Requirements in Annex 33B v102

33.2.8.4.1 PSE PI pair-to-pair resistance and current unbalance

Figure 33–25a — PSE measurement setup for $I_{Con-2P-usb}$

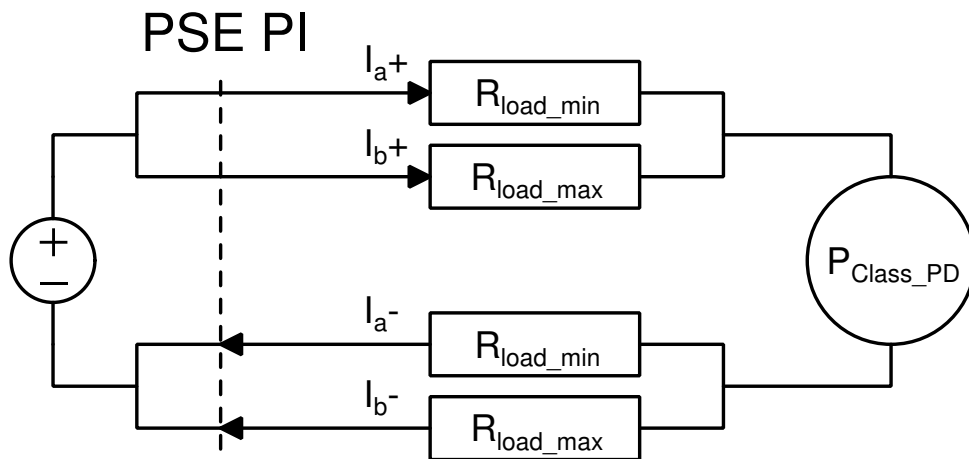
What we need for the PSE section is the mirror image of this. The PSE shall not source more than $I_{Con-2P-usb}$, when connected to such and such PD, given a certain unbalanced channel in between. The right place for this is 33.2.8.4.1. This section contains an equation for R_{PSE_max} and R_{PSE_min} . These are internal parameters to the PSE and I doubt we really need these. For now I leave them untouched.

Add the following material to this section at the end:

A Type 3 or Type 4 PSE shall not exceed $I_{Con-2P-usb}$ on any pair, when connected to a load that draws P_{Class_PD} through load resistances R_{load_min} and R_{load_max} , defined in Table 33–19a. An overview of how to connect the system to measure $I_{Con-2P-usb}$ is defined in Figure 33–25a.
